LEVEL 2 REMODEL
SECTORS 5A, 5B & 6
COLLEGE COMPLEX
LOS MEDANOS COLLEGE
2700 EAST LELAND DRIVE
PITTSBURG, CA 94565

REQUEST FOR INFORMATION

RFI # 143

HVAC Ductwork in Restrooms 230 & 231

Files: RFI# 152.1 MSM Photo Bracing.jpg 101.34 KB
Gobhan Akalan IBP/Arch. 8/18/17

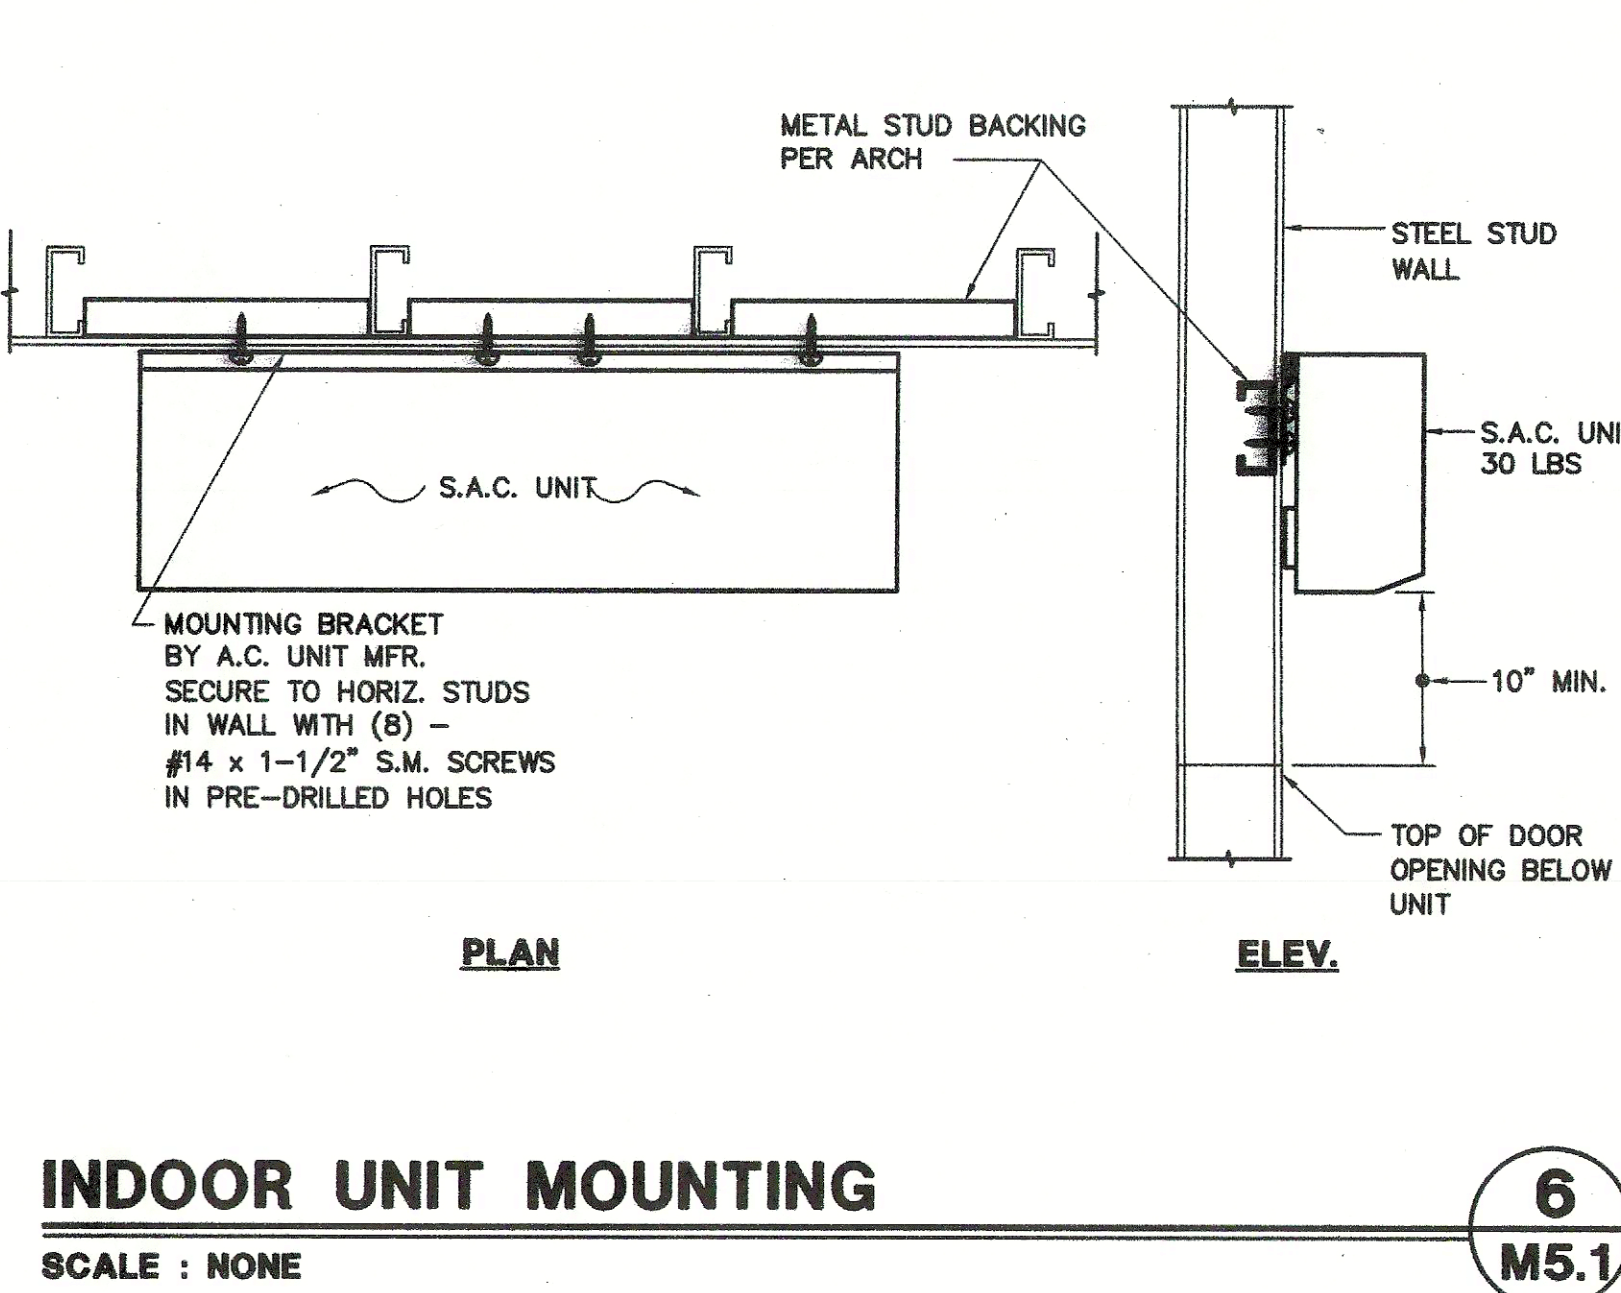
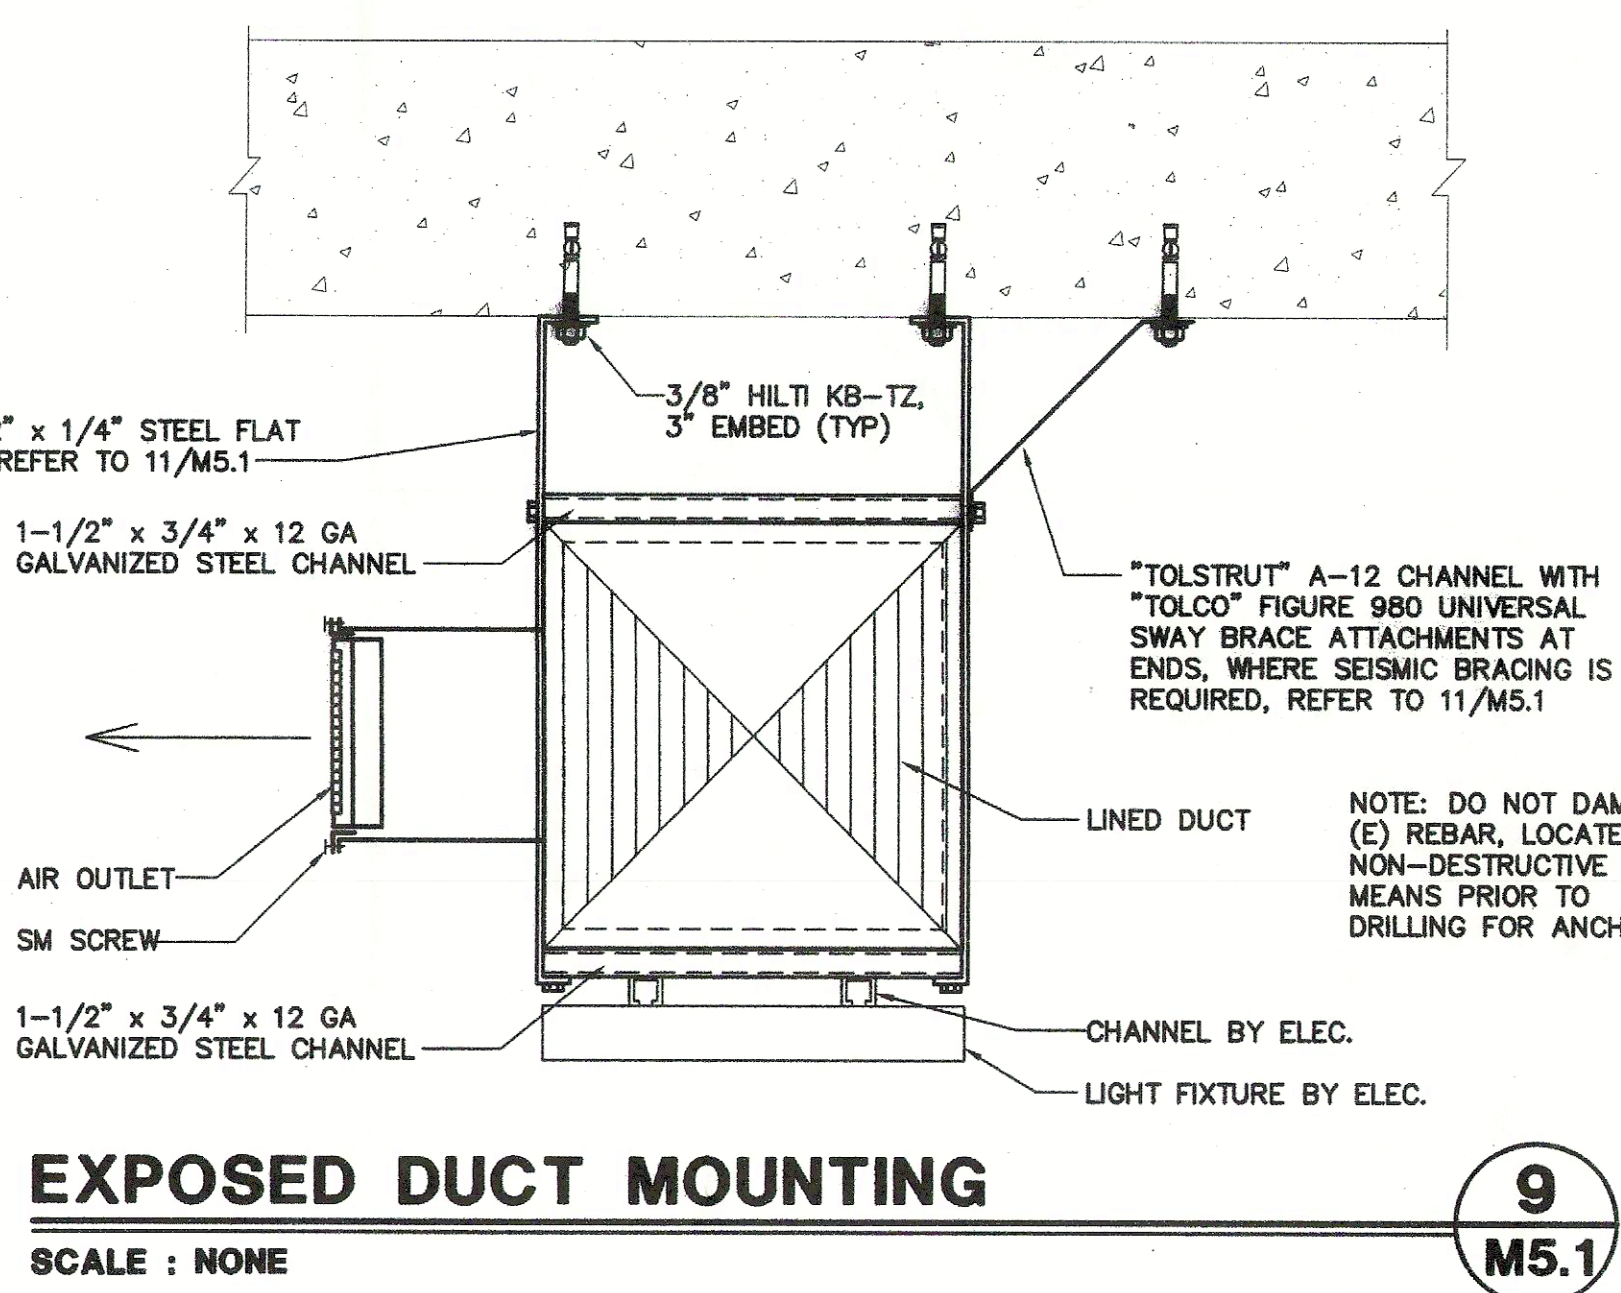
Request: Detail 8/A5.1 shows the Hill KB-1Z anchors installed inward from the vertical support. The existing support studs are centered on the concrete beam above with a stud/coupler connection (see attached photos). The existing support studs will need to be ground flush to make room. Question: what is the minimum distance needed between new and old anchors? Please advise. URGENT

Response: There are approximately 6 locations where the seismic brace detail for the HVAC VAV boxes will not work, they are too close to a wall. This typically occurs in the smaller offices in sectors 5A and 5B. Martinez Sheet Metal is proposing to attach the boxes to the adjacent wall with Unistrut, similar to the installation shown in the attached picture. This picture is in room 252.

Response: Bracing may be installed to wall or deck per 14/A7.3 (see attached marked up photo)

drawing no:
M6.1
drawing of

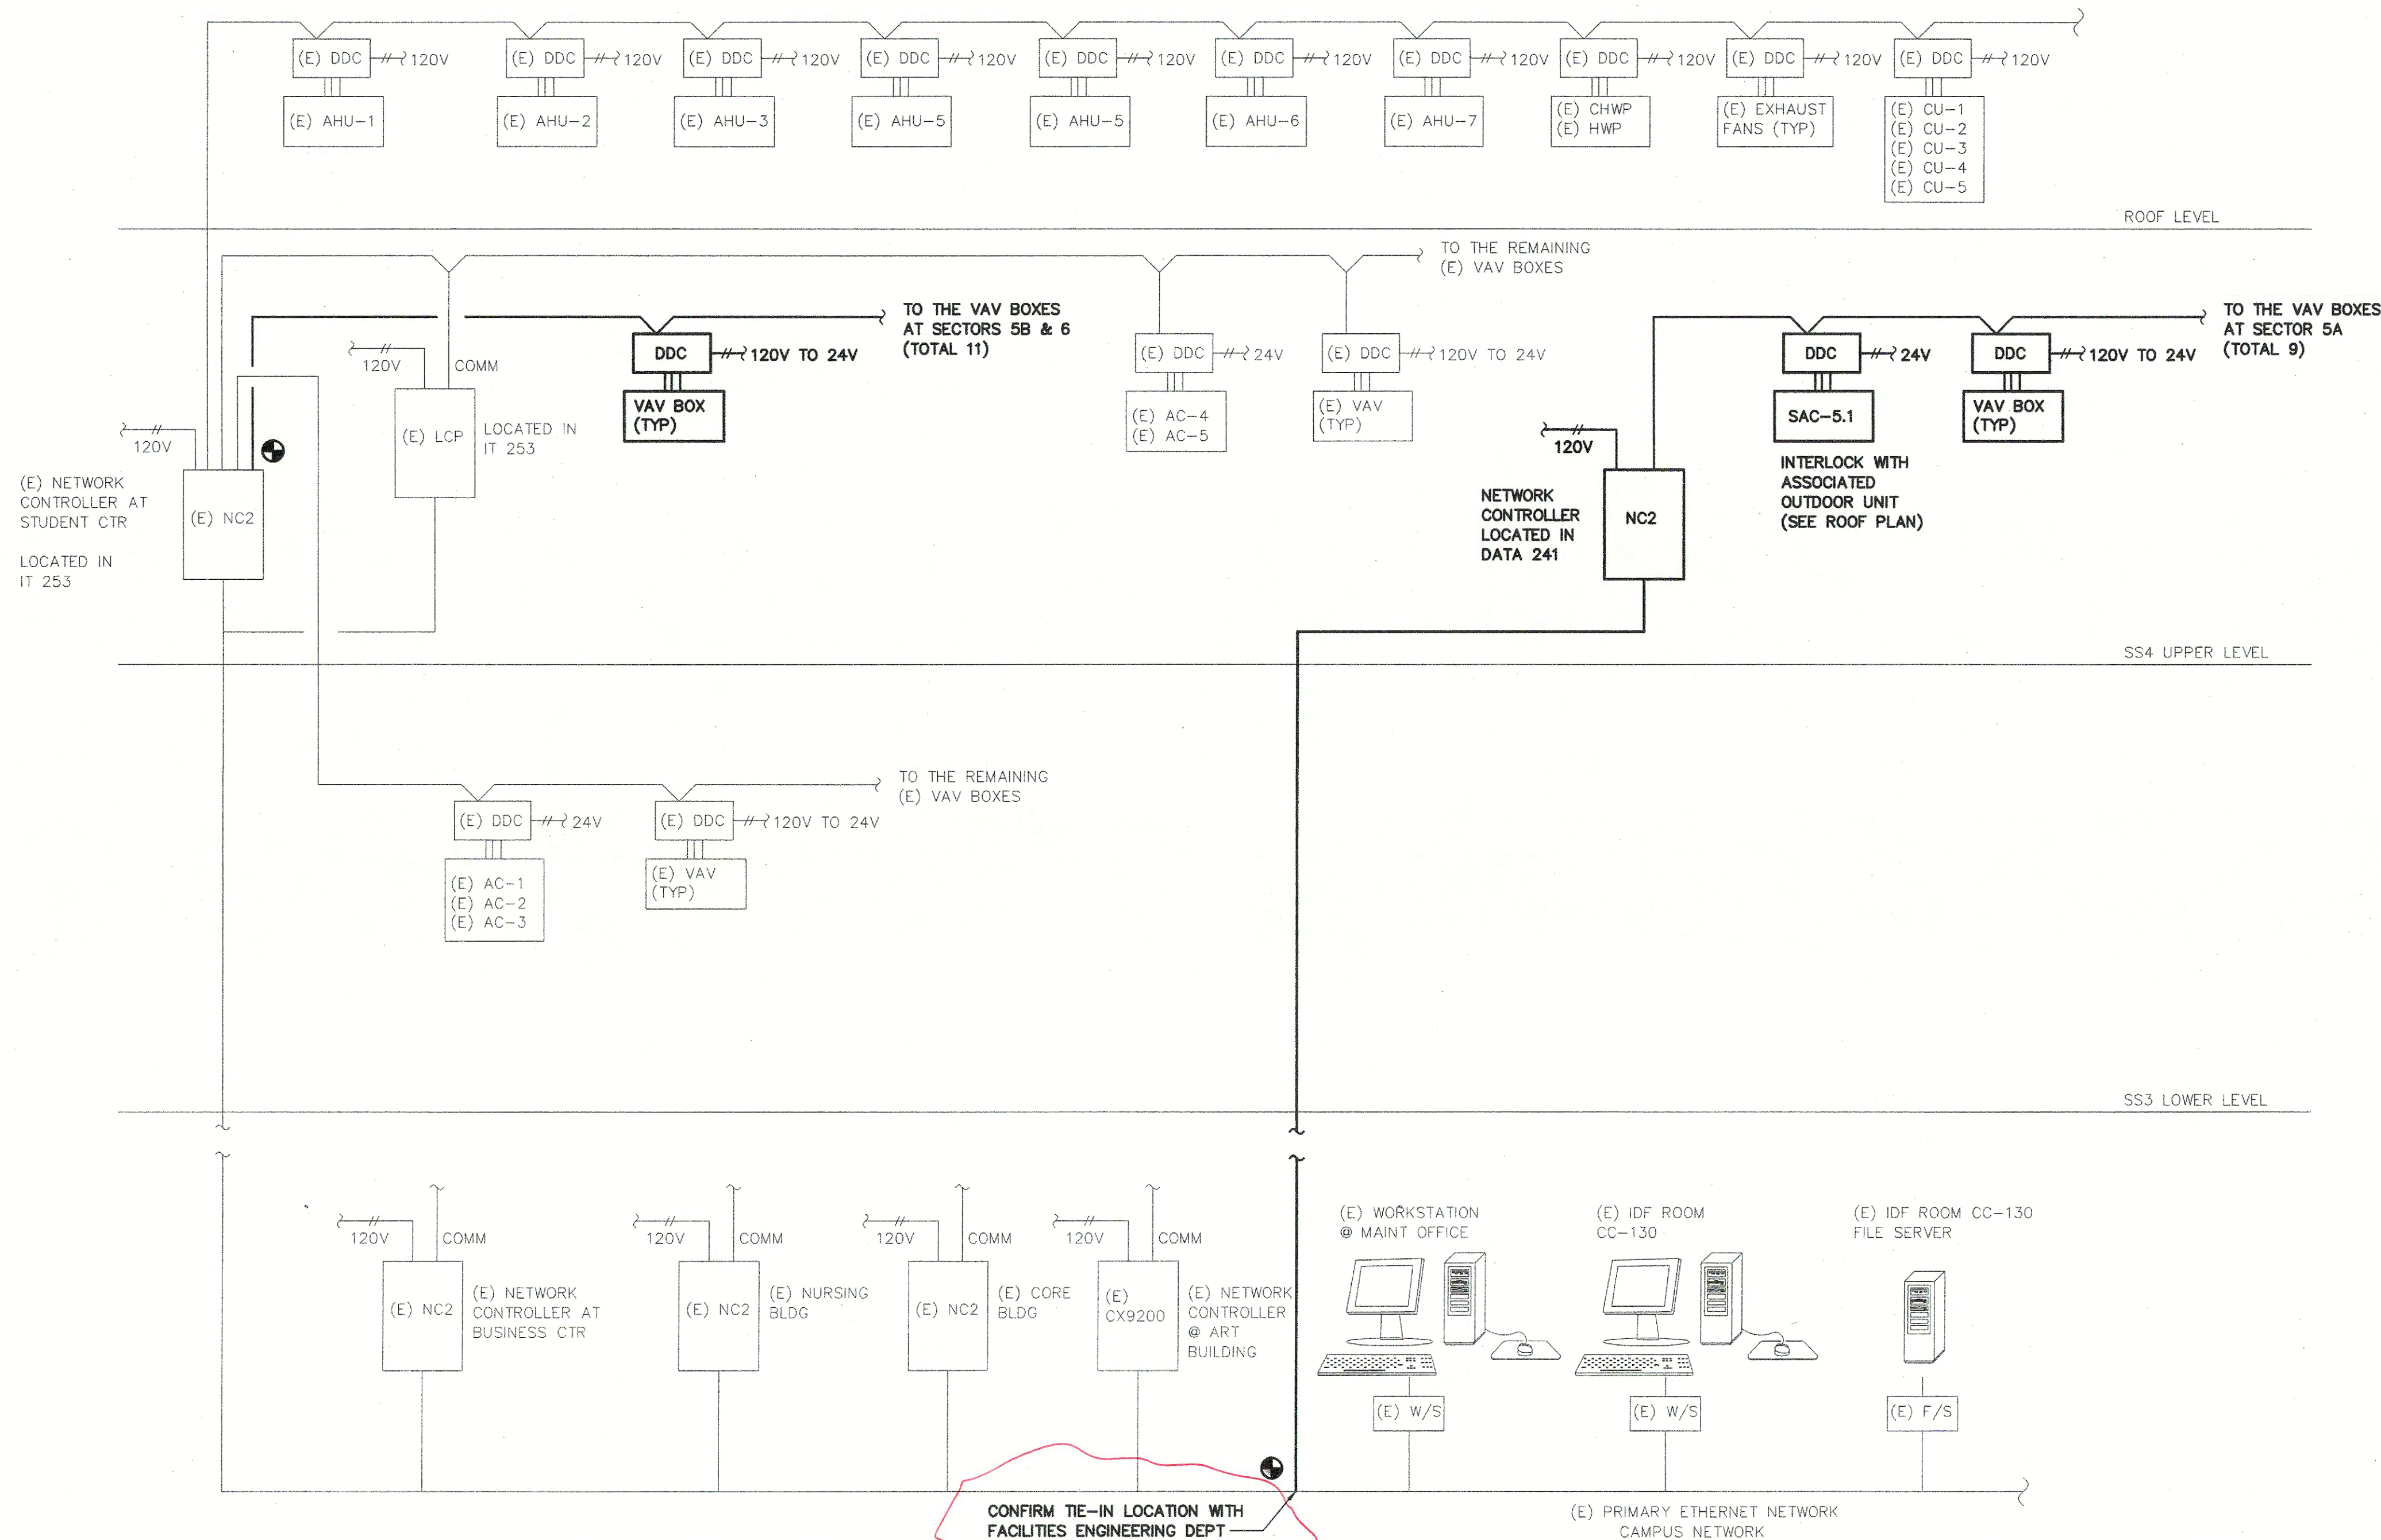
RFI # 77
Locations Rm # 253 & 241
